**ADVISORY REPORT
 FINDINGS, CONCLUSIONS, AND RECOMMENDATIONS**

File: ZON11-00026 – TOTEM STATION MIXED USE PROJECT
 PLANNED UNIT DEVELOPMENT (PUD)

A1.1

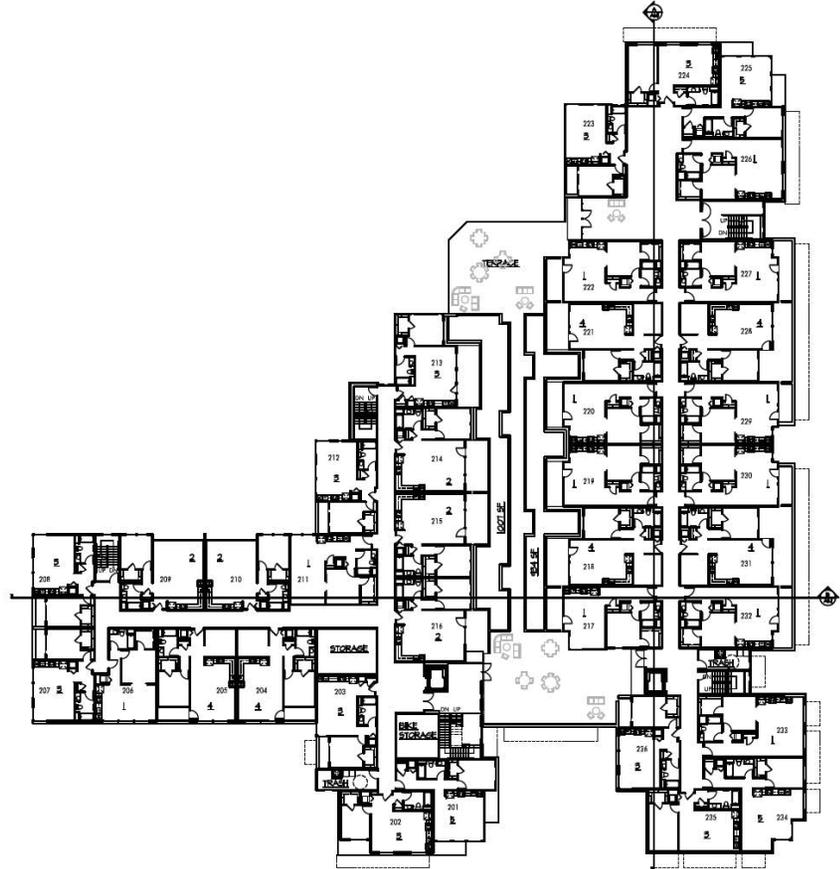
Response: *The bike storage location is now depicted on Sheet A1.1. Bike rack space for a minimum of 11 bikes shall be provided based on a total count of 129 parking stalls.*

A5.1

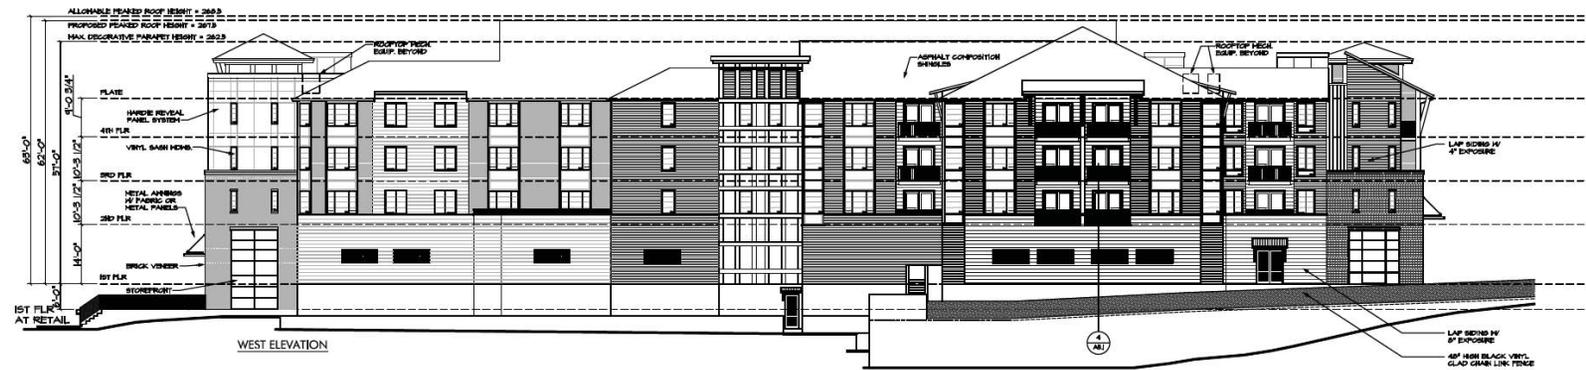
Response: Drainws A5.1, A5.2 and A5.3 have been updated to more clearly show compliance with the parapet height limits.

Figure NRH-10: North Rose Hill Urban Design

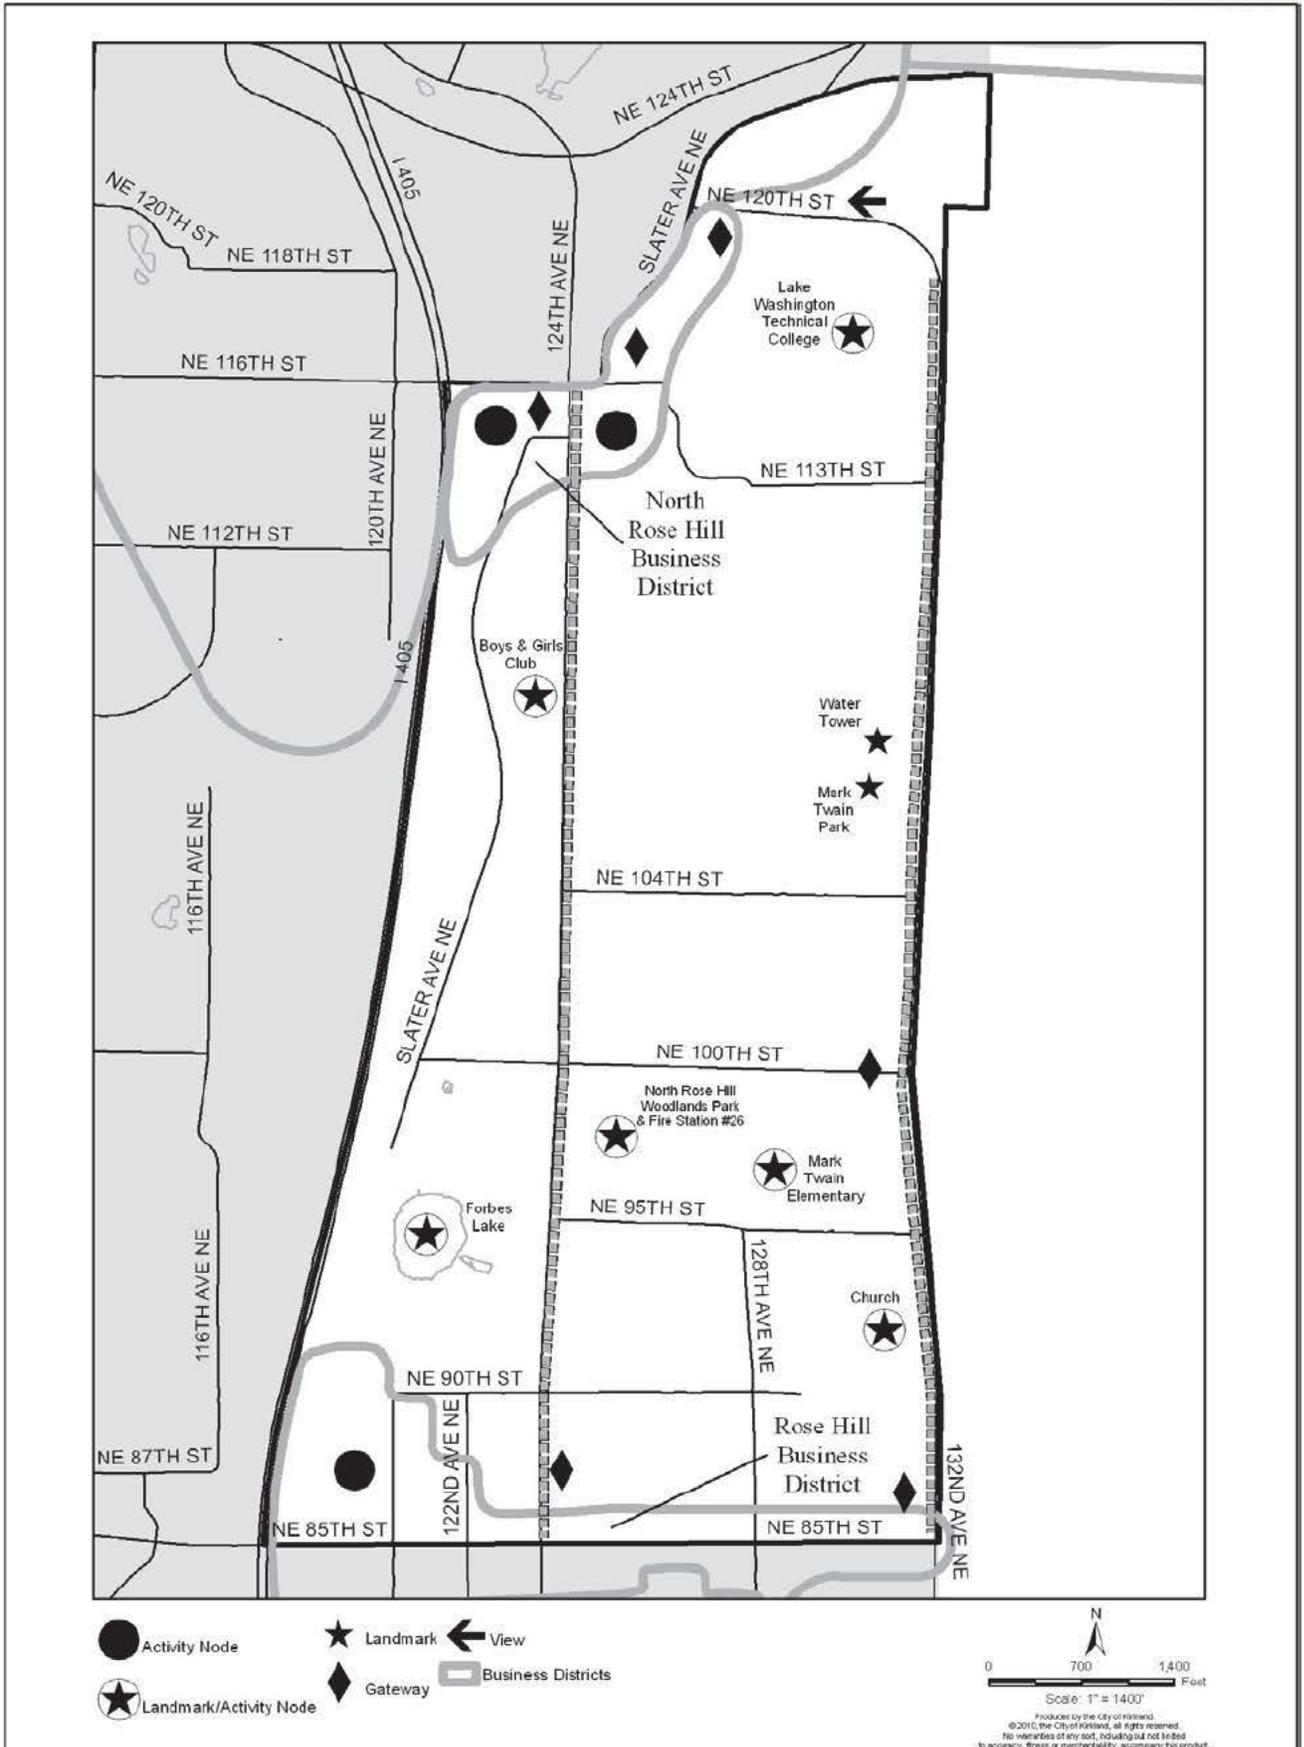
- 1) *Comment:* The applicant agreed to post a North Rose Hill neighborhood sign on the property at the NE 116th Street and 124th Avenue NE intersection.

- 2) *Staff Response:* Comprehensive Plan policy NRH37.1 states: *Use public and private efforts to establish gateway features at the locations identified in Figure NRH-10.* Comprehensive Plan *Figure NRH-10: North Rose Hill Urban Design* identifies a gateway along NE 116th Street near the 124th Avenue NE intersection (see Enclosure 6). During the design review process, the DRB decided against requiring the standard neighborhood gateway signage and approved a gateway design which incorporates a small plaza and rose garden along NE 116th Street into the frontage improvements. A second rose garden was added between the building and sidewalk along 124th Avenue NE near the intersection to continue the rose garden theme around the corner. Enclosure 2 contains the landscape/gateway plan as approved by the DRB.
